BMP NUMBER: **CC019**

Project Name: Kingsmill Pond Spillway Repair
County Plan No.: E&S 022-15
Stormwater Management Facility: Wet Pond
BMP Phase #: ☐ I ☐ II ☐ III ☐ IV (These are County assigned phasing/colors on GIS map.)

Project Name: Spillway Retrofit and Repair - Kingsmill Pond
Structure/BMP Name: Kingsmill Pond Dam
Project Location: 144-198 Macaulay Rd. Williamsburg, Virginia 23185
BMP Location: 144-198 Macaulay Rd. Williamsburg, Virginia 23185
County Plan No.: E&S-022-15 VAHU6 HUC Code: JL34

Reference: **Spillway Retrofit and Repair – Kingsmill Pond (E&S-022-15) Record Drawing and Construction Certification Forms.**

SHEET R1

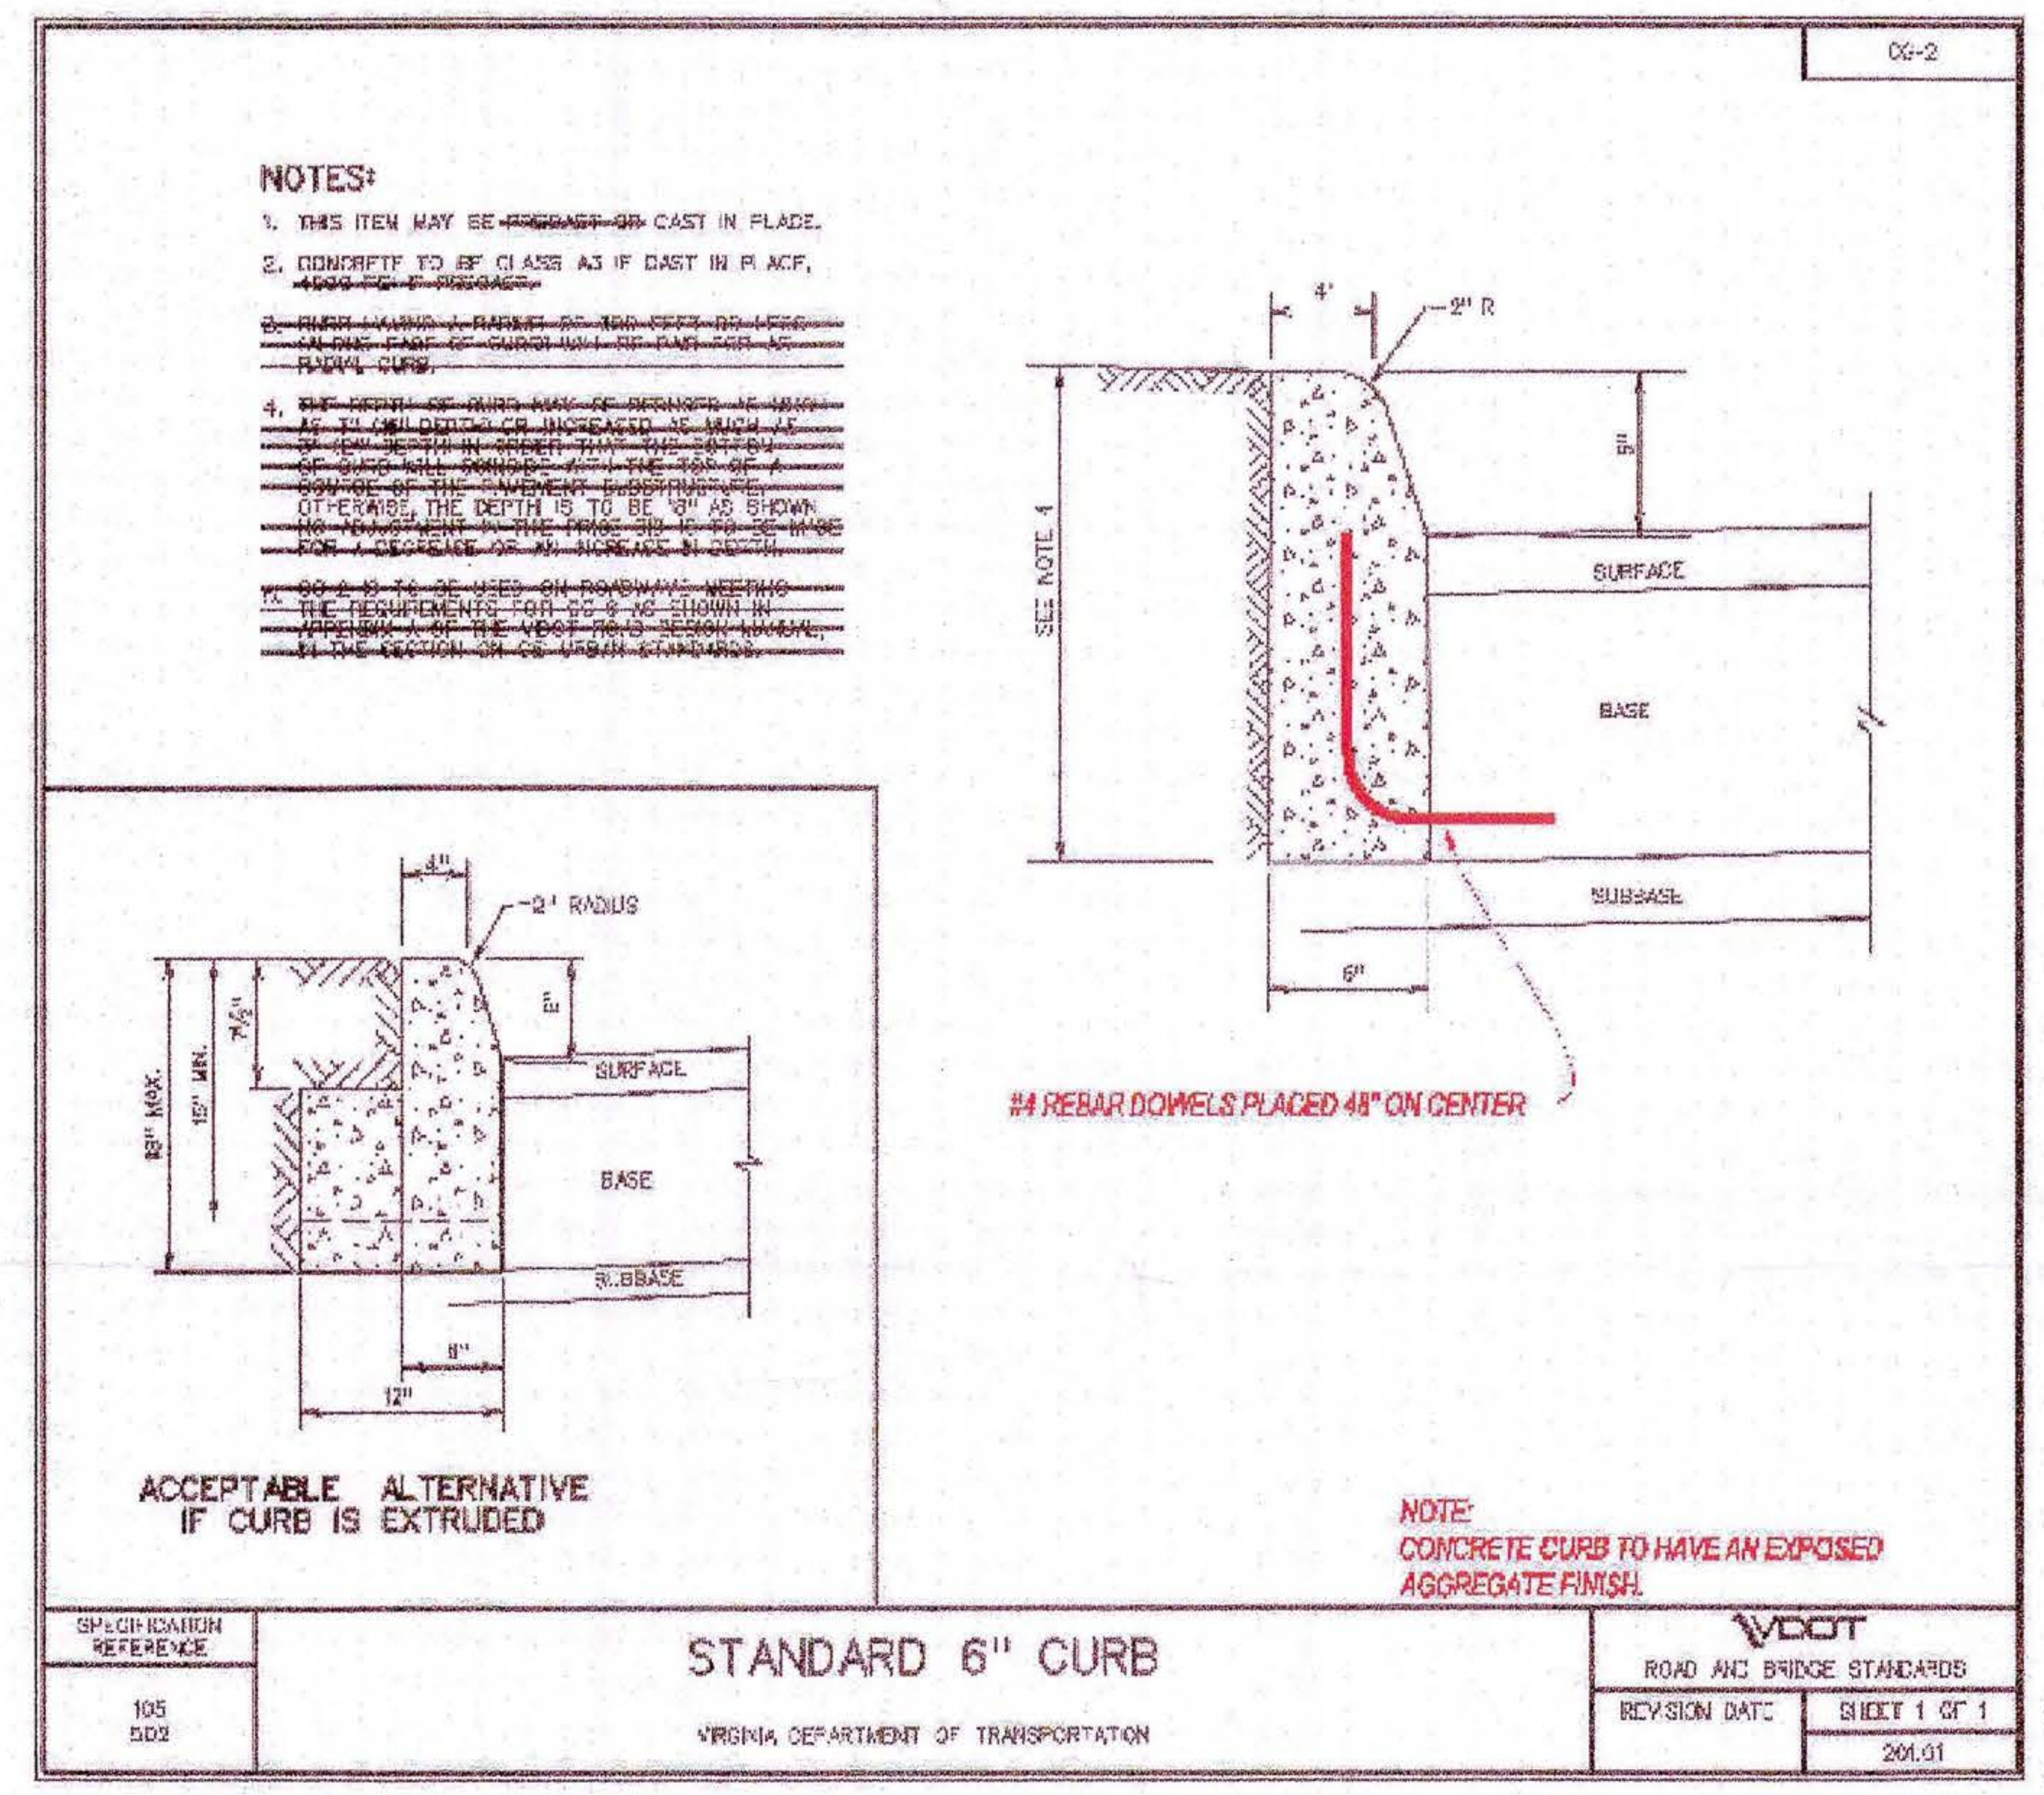
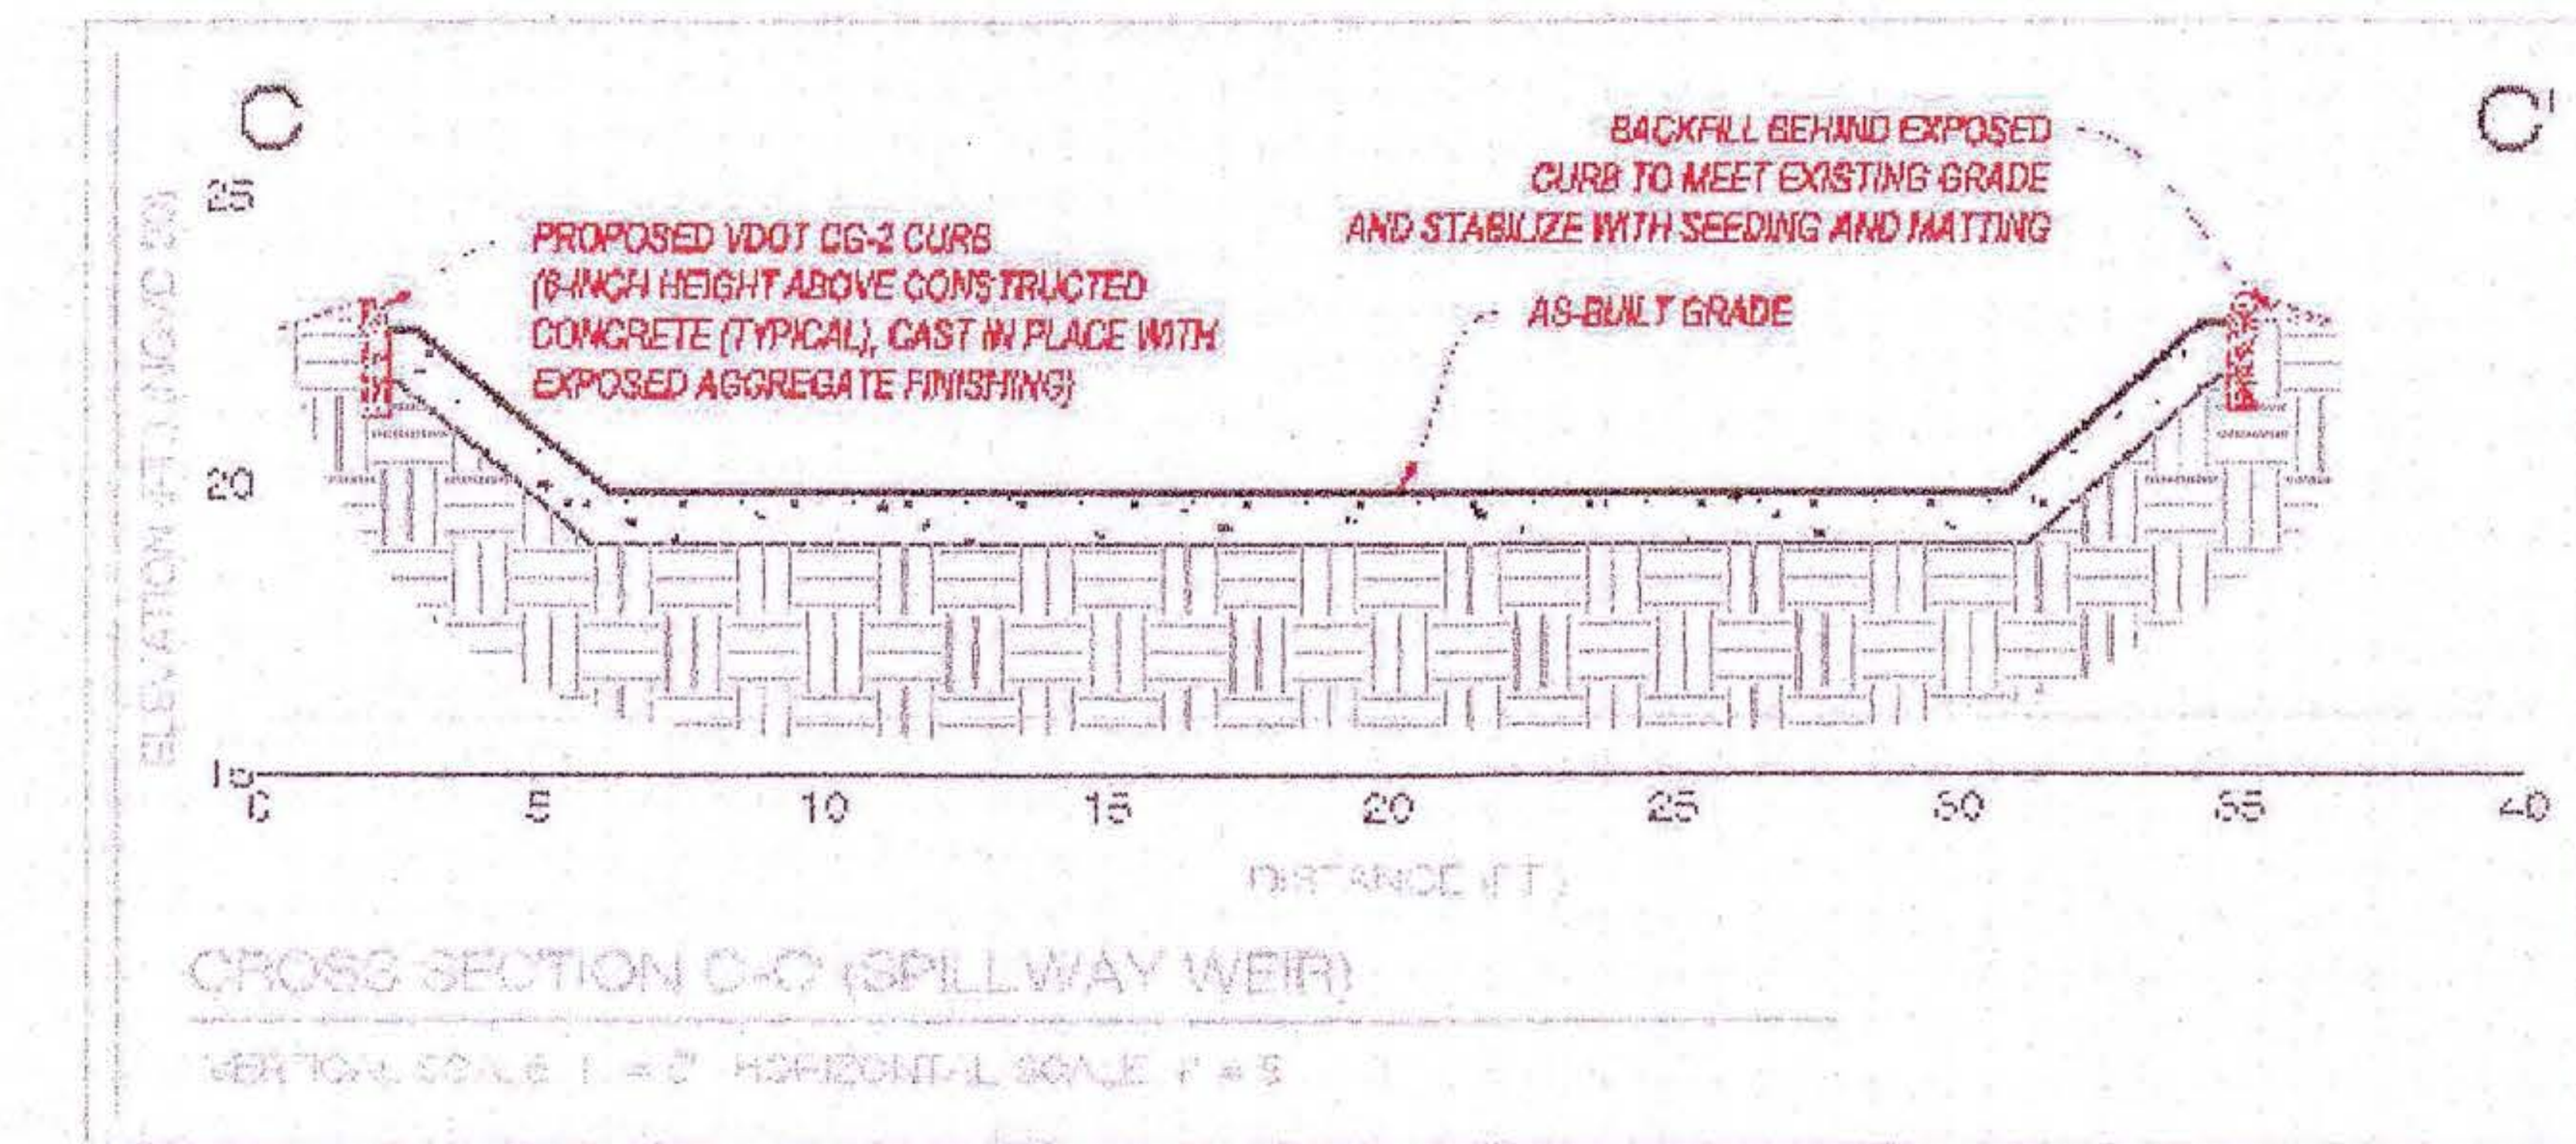
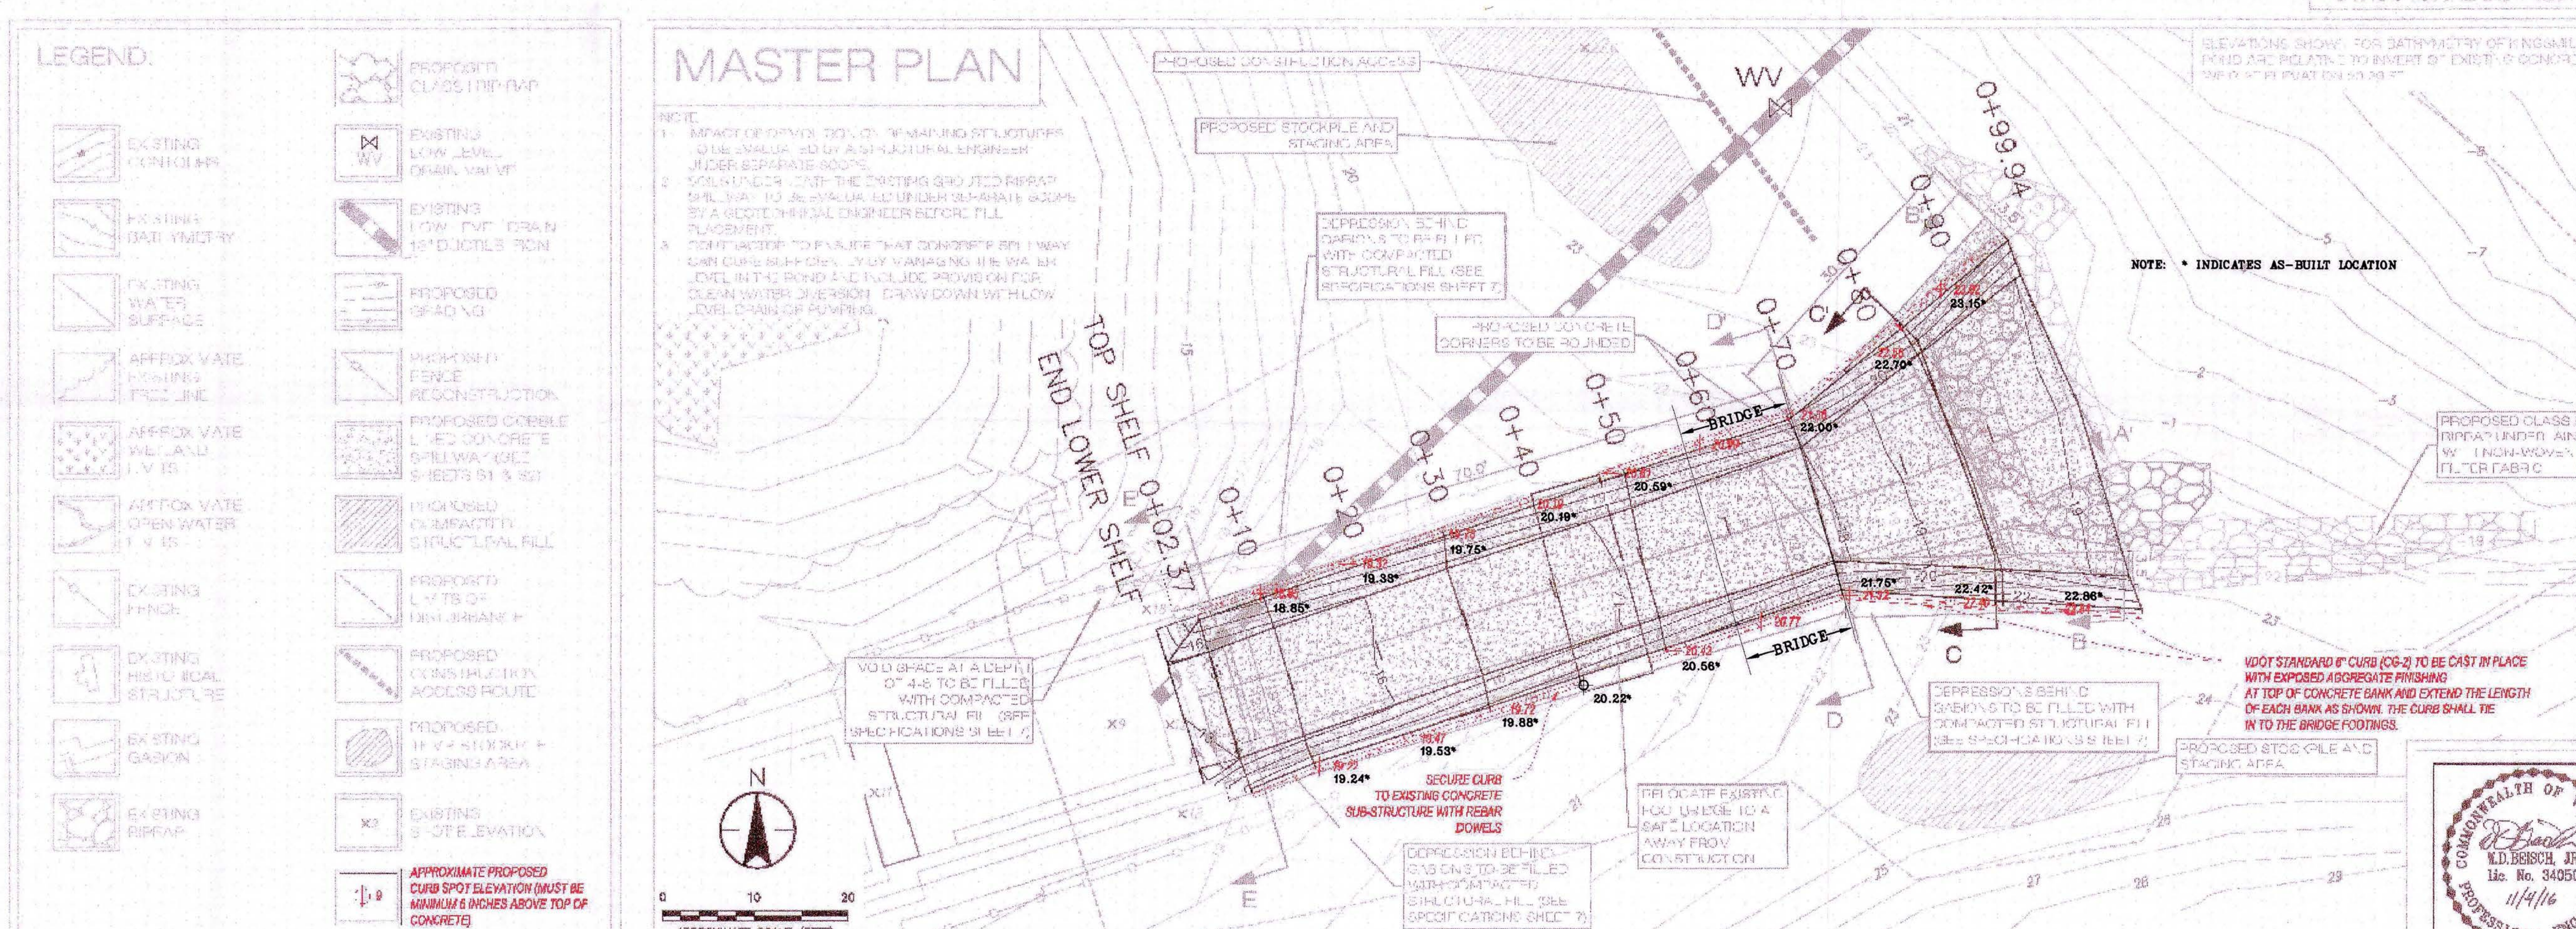
NOTE: THIS SUBMITTAL (COVER AND SHEET R1) HAVE BEEN MODIFIED TO REFLECT AGREED-UPON FIELD CHANGES. THE SUBMITTAL IS ACCOMPANIED BY A REVISED HYDRAULIC ANALYSIS DEPICTING THE ADJUSTED SPILLWAY CONFIGURATION.
